**REMARKS/ARGUMENTS**

**Drawing Objections**

FIG. 2

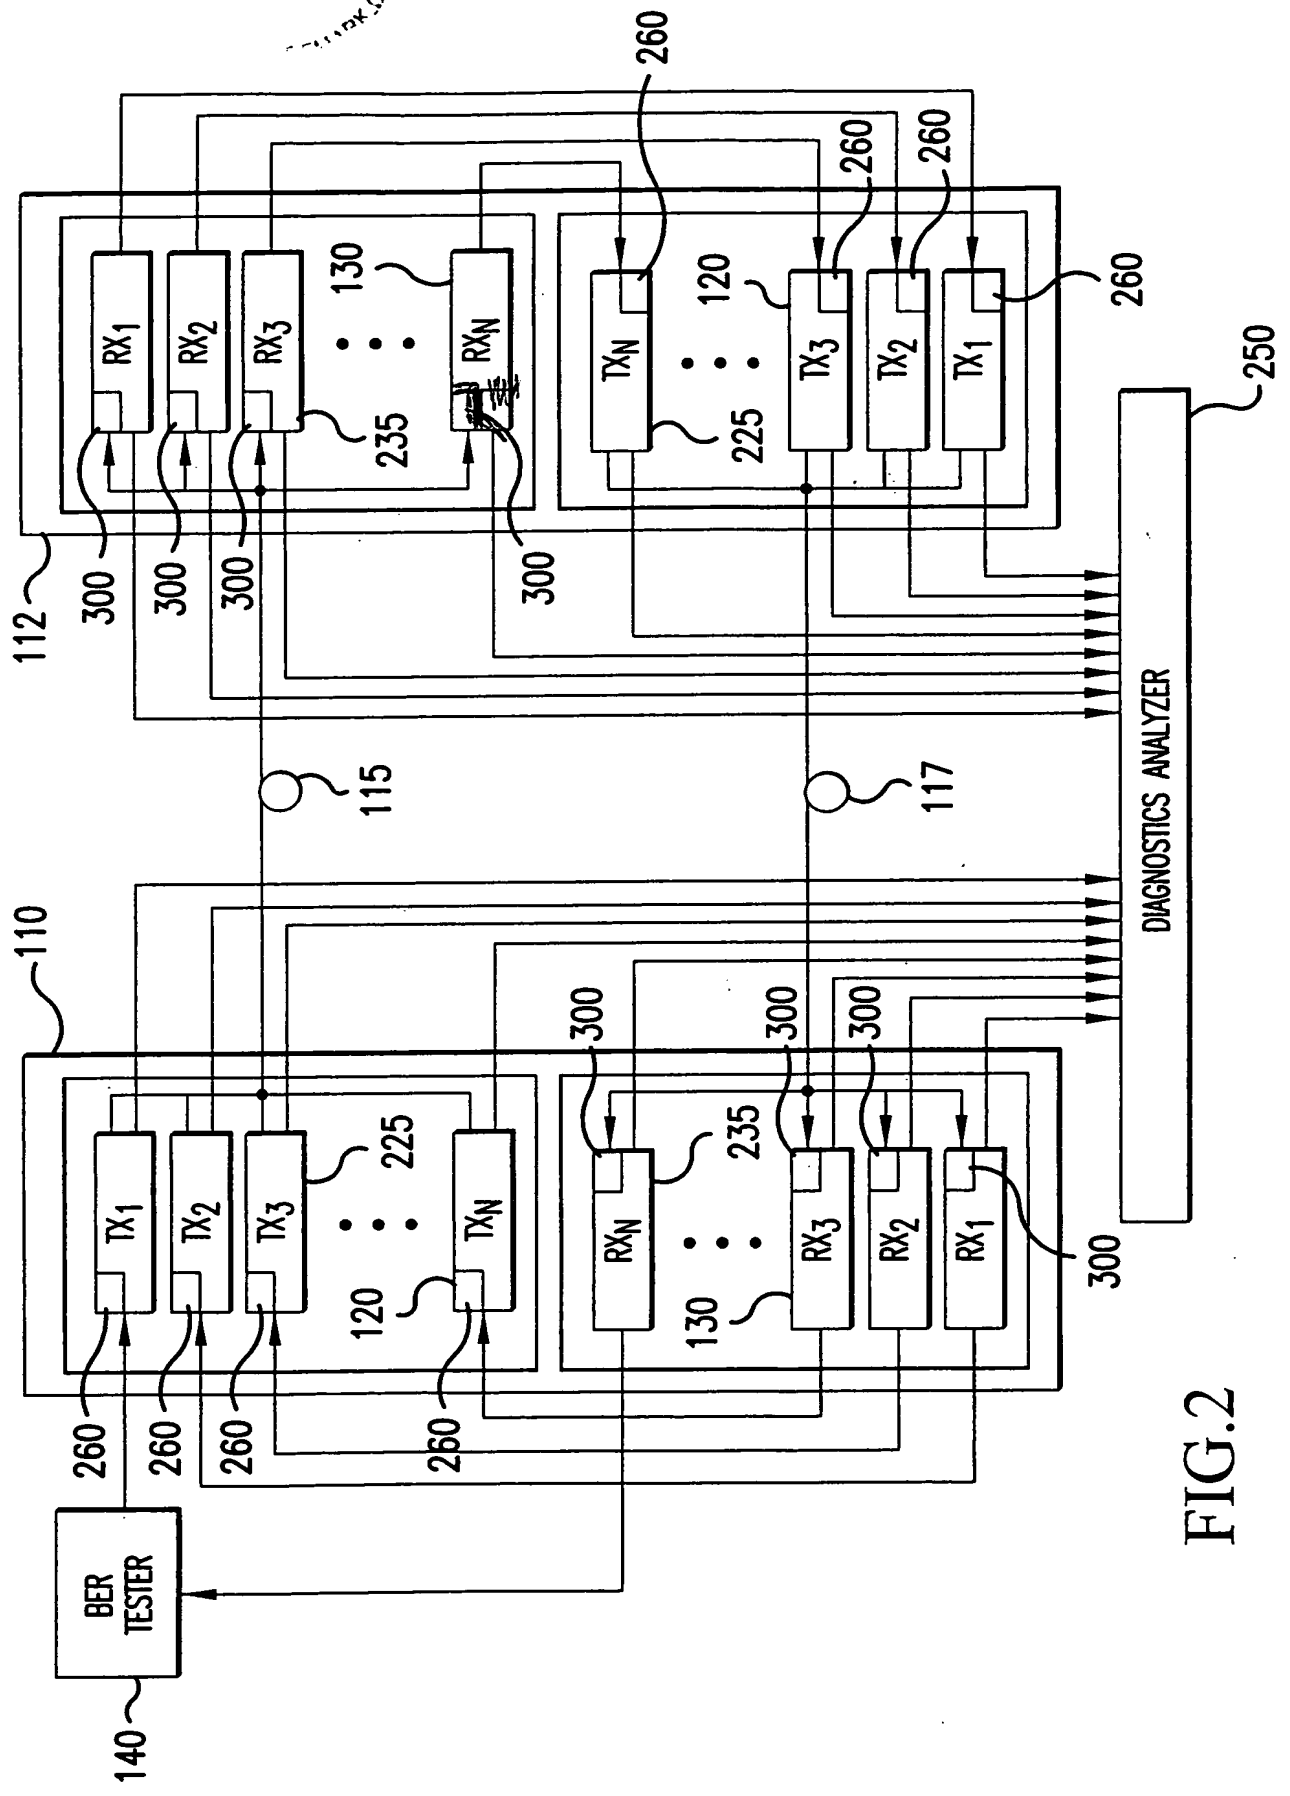
In the Office Action, the Examiner indicated that the drawing corrections filed on May 26, 2004 accommodated the drawing corrections raised in the Office Action of March 25, 2004. However, the Examiner issued a new objection to the drawings. Specifically, the Examiner indicated that the box 112 indicating the internal performance monitor 300 of RX<sub>N</sub> should be moved to the upper left corner of RX<sub>N</sub>.

Filed concurrently herewith is a drawing correction in which the box 112 has been moved as requested by the Examiner.
